# PLANNING & ZONING COMMISSION

APRIL 08, 2024, 7:00 PM

Halff Associates, Inc. (Halff) was requested by the City of Sanger to review the final plat and drainage study in support of the engineering plans for the Lakeside Estates located near the intersection of McReynolds Road and FM 455 E. The subject tract is located within the City of Sanger's ETJ. The submittal was prepared by Kirkman Engineering and dated March, 2024. The preliminary plat and drainage comments were found acceptable by Halff in September 2023.

# PLANS FOR THE CONSTRUCTION OF PAVING, GRADING & DRAINAGE IMPROVEMENTS

**SUNRISE DRIVE [STA 7+00 - STA 16+00]**

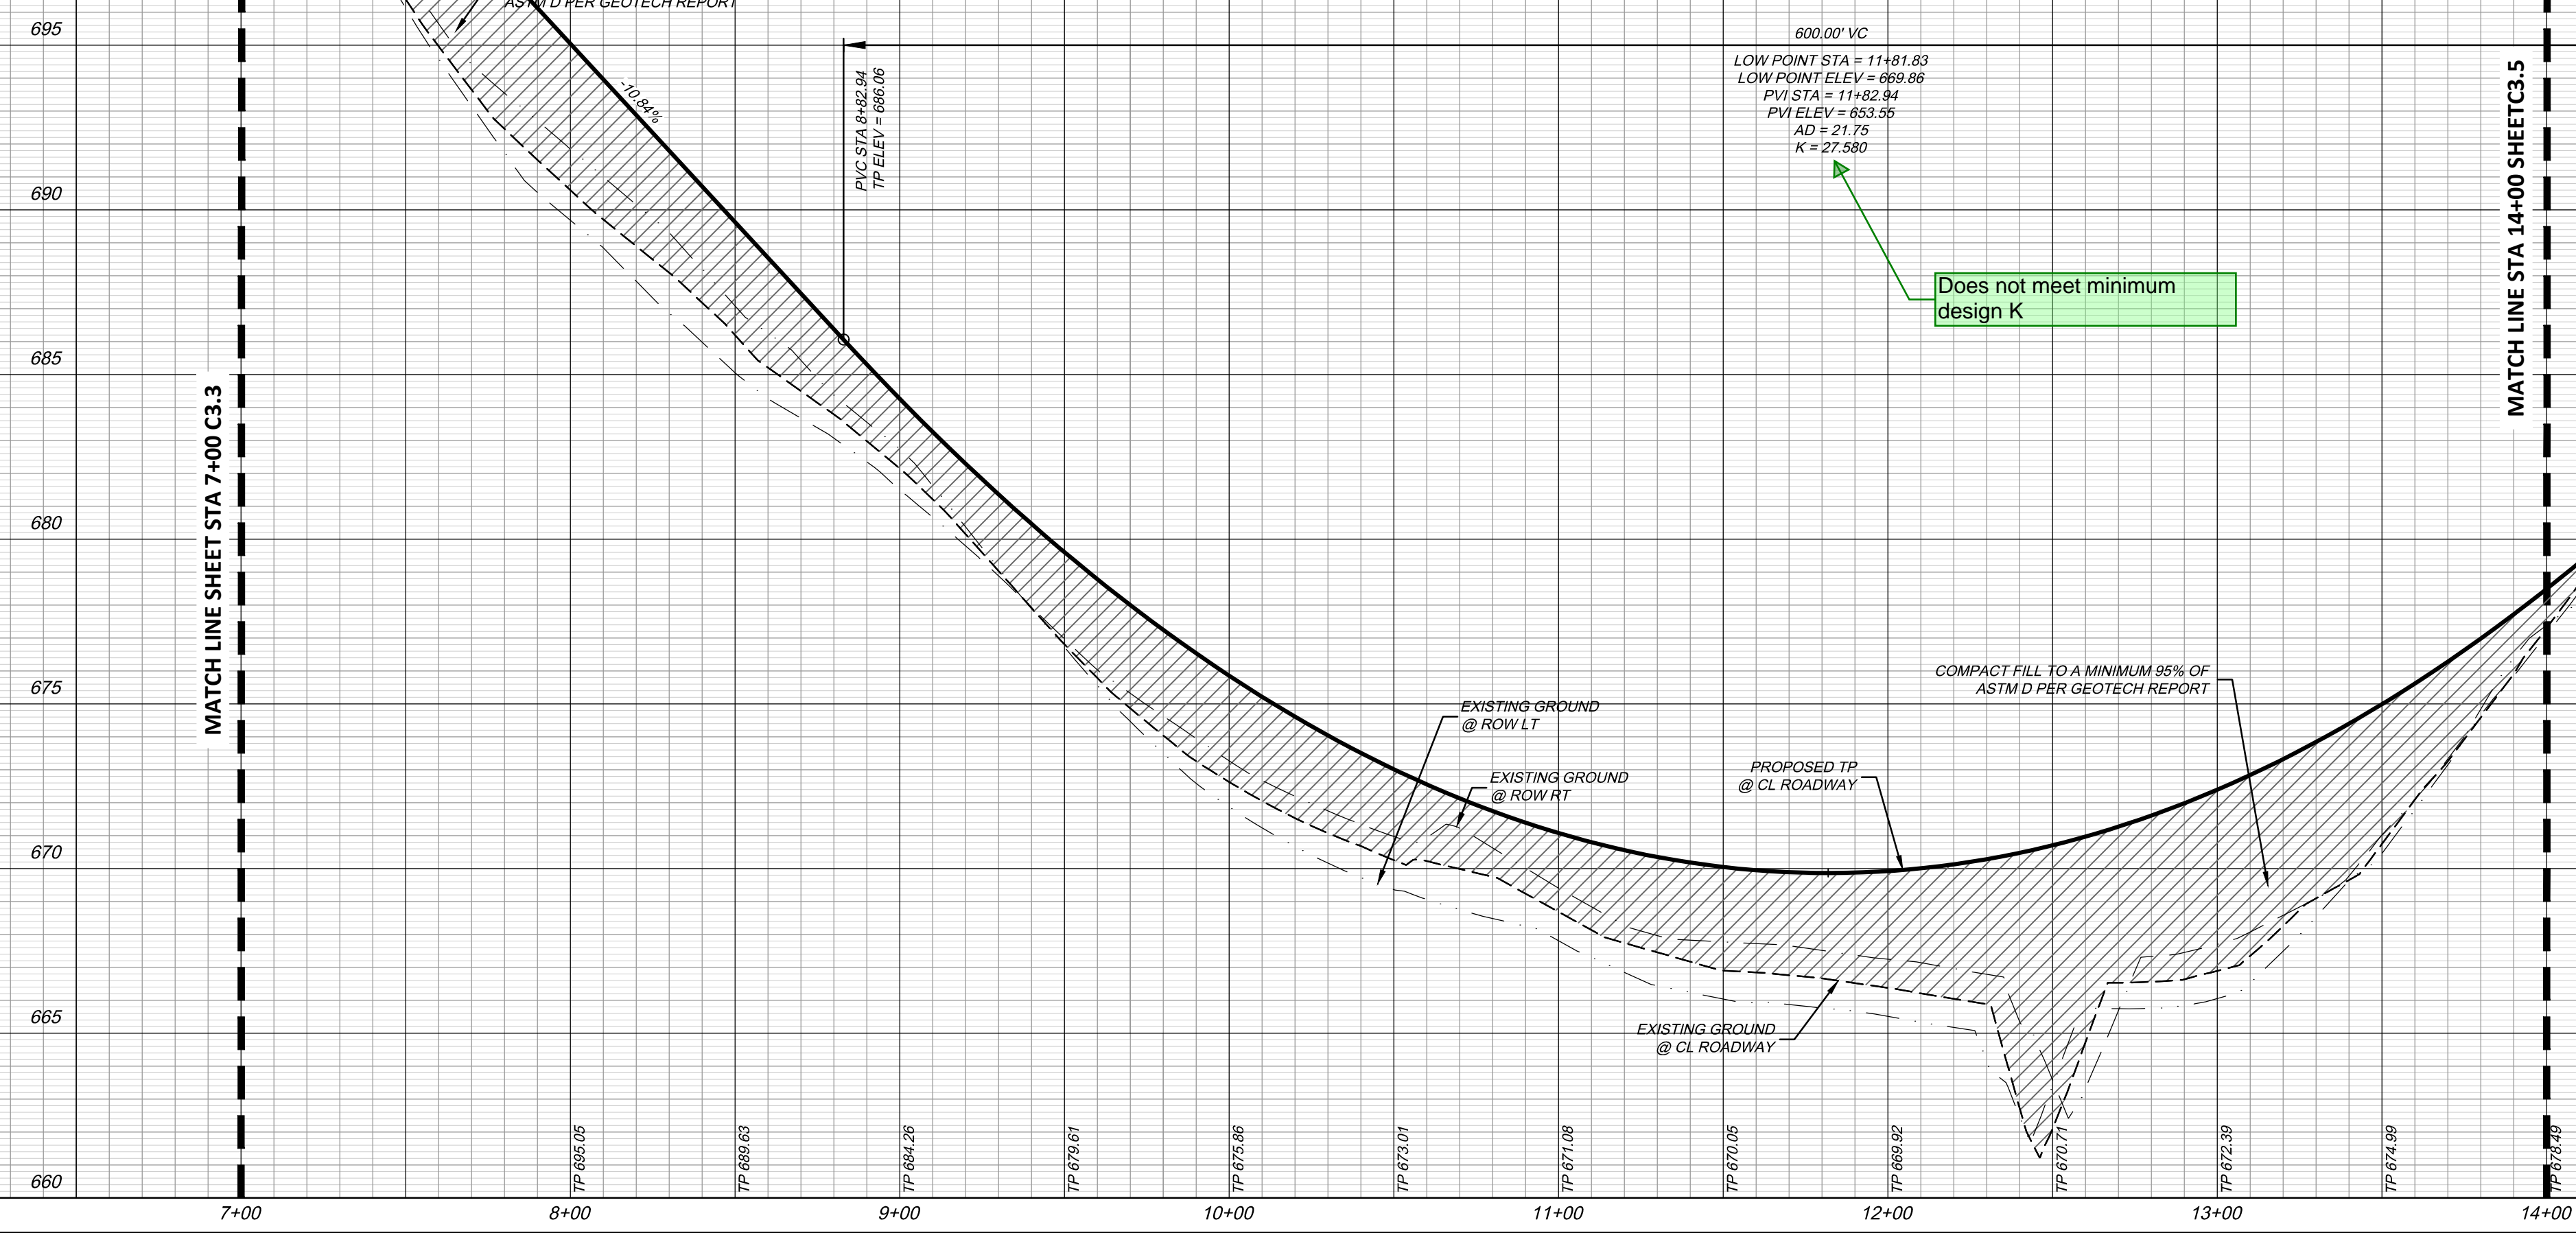
Does not meet minimum design K
